Cree® LP6 Series LED Product Change Notification

PCN Reference Number: CREE-PCN-0860

Date Issued: August 19, 2019

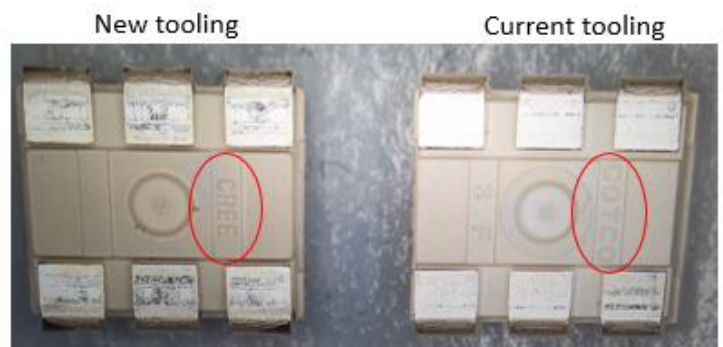
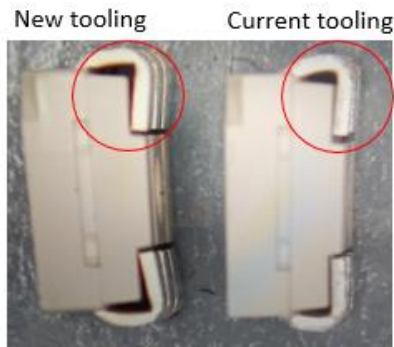
The current substrate mold for LP6 series LEDs has reached its End of Life (EOL). Cree has qualified a new mold.

The visual differences are shown below:
